**EXPRESS TERMS  
FOR  
PROPOSED BUILDING STANDARDS  
OF THE  
DEPARTMENT OF HOUSING AND COMMUNITY DEVELOPMENT  
REGARDING AMENDMENTS TO THE 2010 CALIFORNIA BUILDING CODE  
CALIFORNIA CODE OF REGULATIONS, TITLE 24, PART 2, CHAPTER 11A ONLY  
(HCD 02/10)**

The Department of Housing and Community Development (HCD) proposes to make necessary changes to the 2010 edition of the California Building Code (CBC), Chapter 11A – Accessibility, as presented on the following pages.

### **14. HCD proposes to amend Division VII – FIGURES as follows:**

FIGURE 11A-1B— HEADROOM CLEARANCE AND OVERHANGING OBSTRUCTION

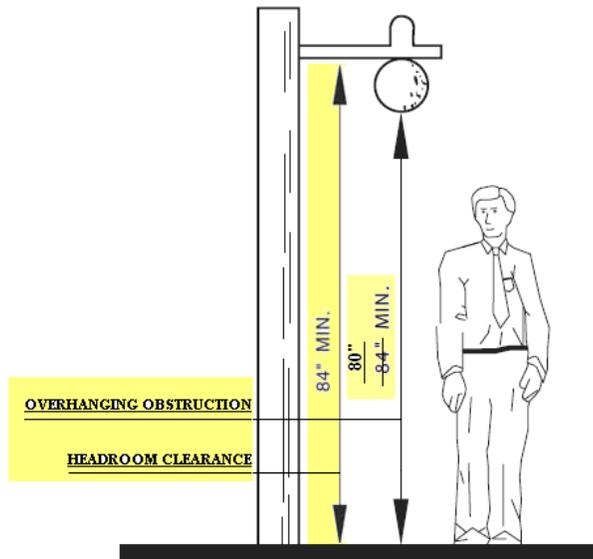
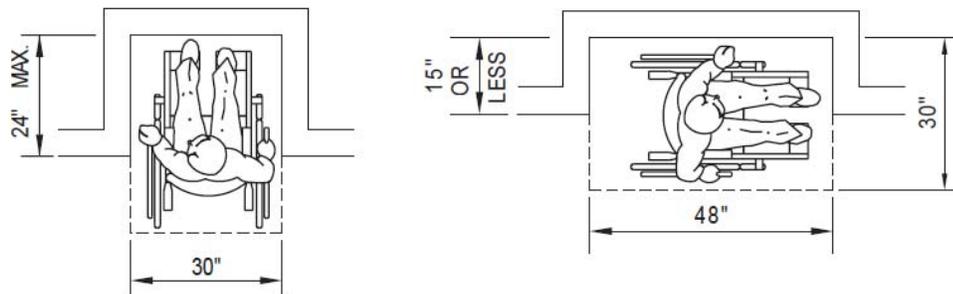
#### **FIGURE 11A-1B – OVERHANGING OBSTRUCTION**

Amend title to read “Headroom Clearance and Overhanging Obstruction”.

Correct the dimension of “Overhanging Obstruction”: Delete 84” and replace with 80”.

Add dimension (84”) for “Headroom Clearance”.

Indicate the location of measurements for “Overhanging Obstruction” and “Headroom Clearance”.

FIGURE 11A-1H—MINIMUM CLEAR FLOOR SPACE FOR WHEELCHAIRS

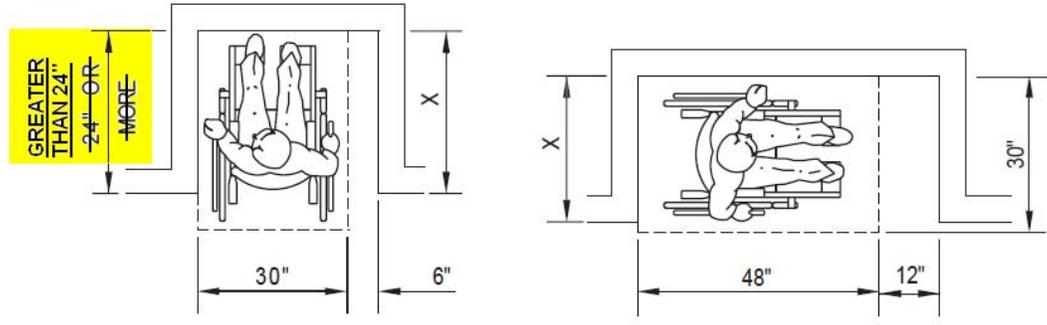
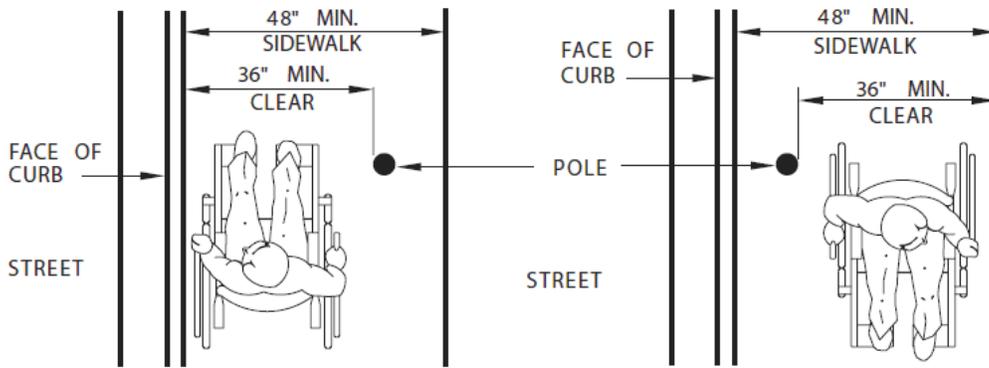
#### **FIGURE 11A-1H – MINIMUM CLEAR FLOOR SPACE FOR WHEELCHAIRS**

Delete “24” or more” and replace with “greater than 24”.

FIGURE 11A-5A—RAMPS AND SIDEWALKS

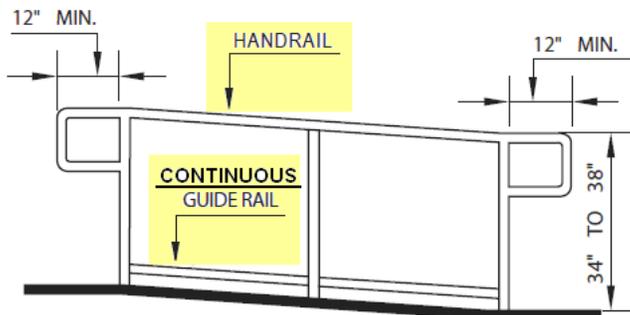
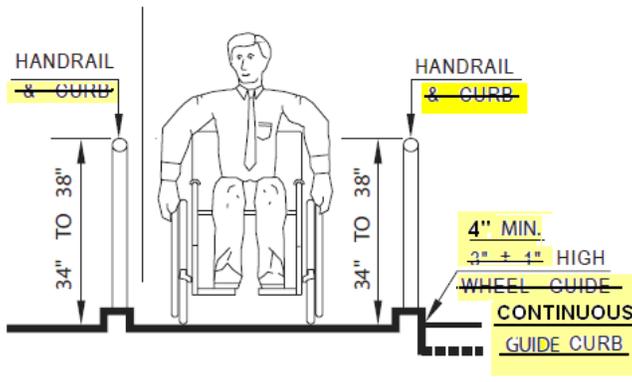
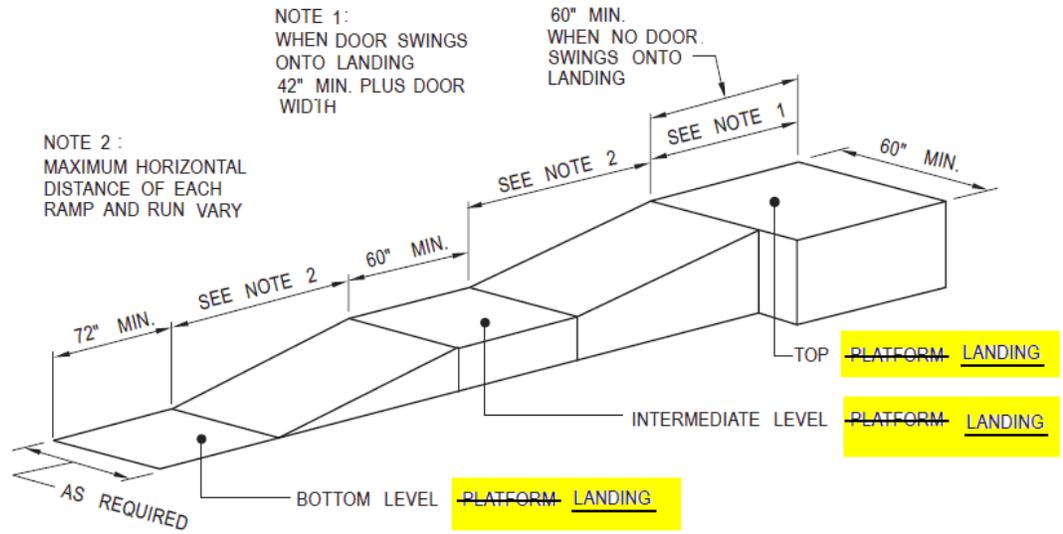
#### **FIGURE 11A-5A – RAMPS AND SIDEWALKS**

##### **Diagram (b):**

Amend title to read “Handrail and Guide Rail”;

Indicate location of handrail and guide rail;

On the Guide Rail Detail, delete Guide Rail centered at 3” ± 1” and replace with <4”.

**Diagram (c):**

Amend title to read "Guide Curb";

Delete "& Curb" below "Handrail" on both sides of wheelchair;

Delete  $3" \pm 1"$  and replace with  $4" \text{ min.}$ ;

Delete "Wheel Guide" and replace with "Guide Curb";

Delete "Wheel Guide Detail" and replace with "Guide Curb Detail".

FIGURE 11A-6C—RAMP DIMENSIONS

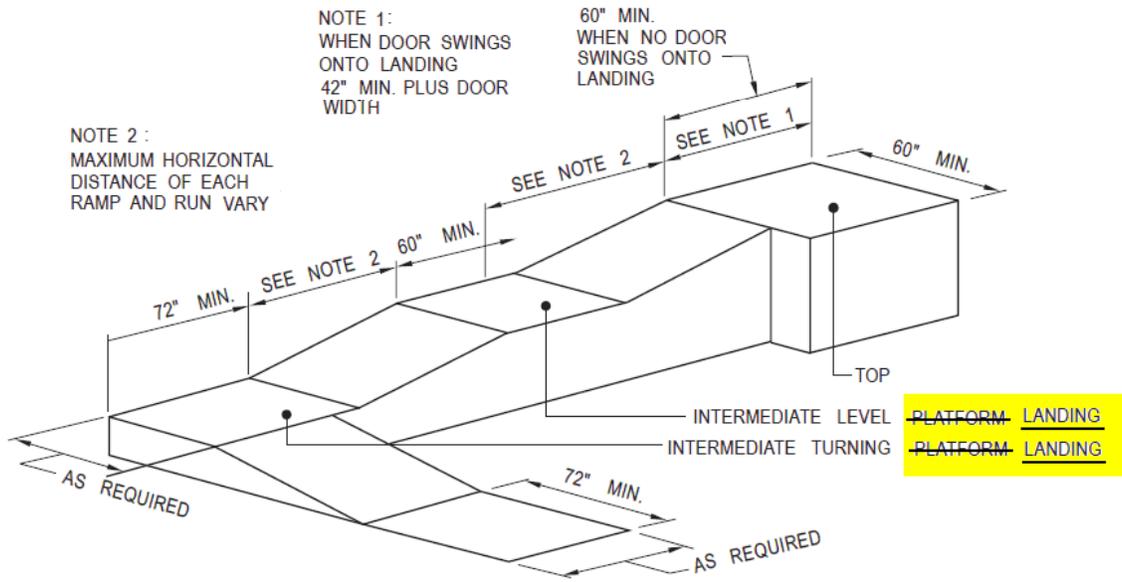
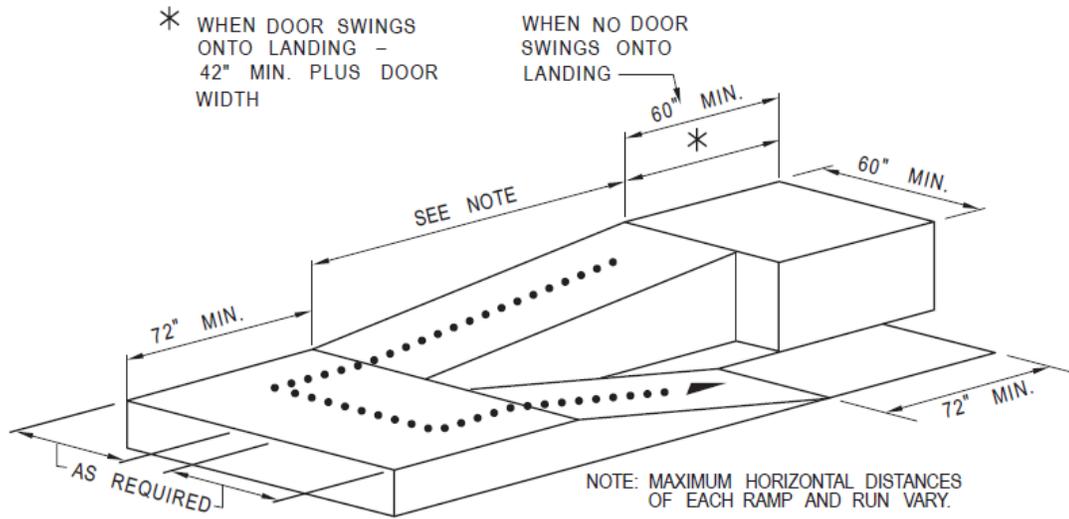
**FIGURE 11A-6C – RAMP DIMENSIONS**

Delete "platform" and replace with "landing".

FIGURE 11A-6D—RAMP LANDING AND DOORWAY

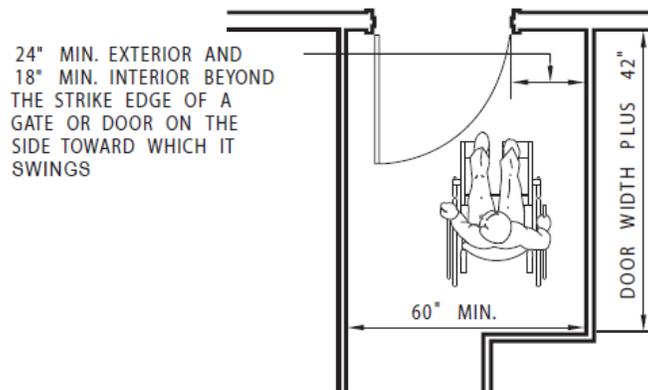
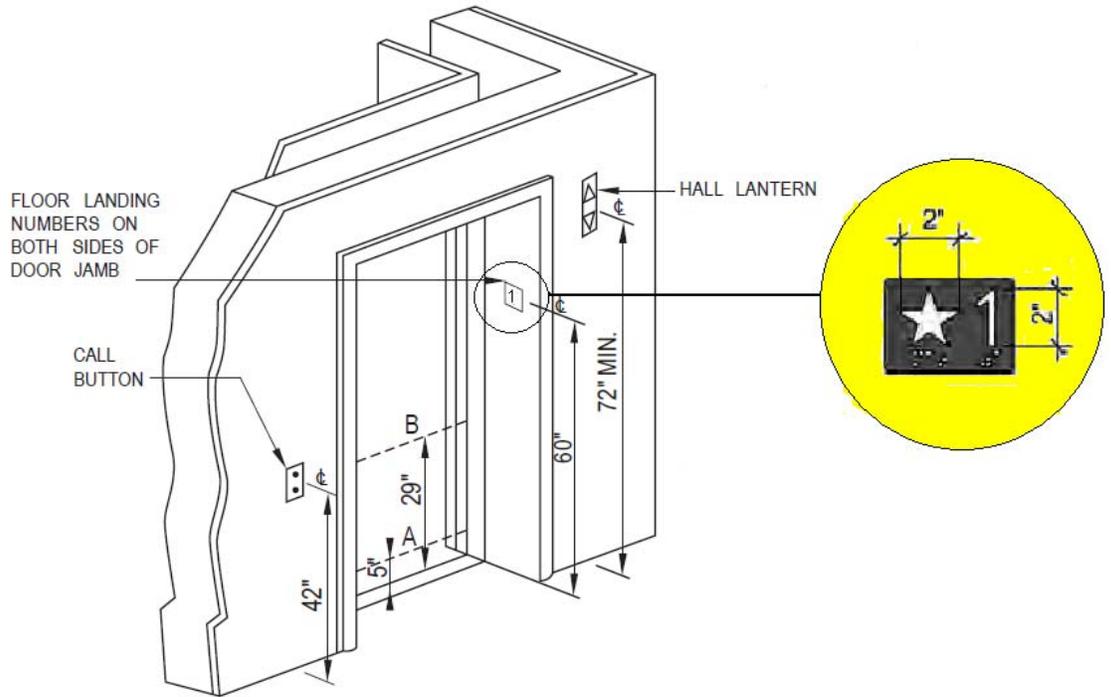
**FIGURE 11A-6D – RAMP LANDING AND DOORWAY**

Delete "platform" and replace with "landing".

FIGURE 11A-7C—HOISTWAY AND ELEVATOR ENTRANCES

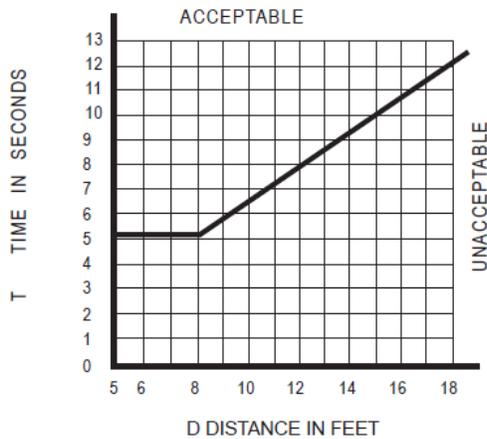
**FIGURE 11A-7C – HOISTWAY AND ELEVATOR ENTRANCES**

Include enlarged diagram of the floor designation sign.
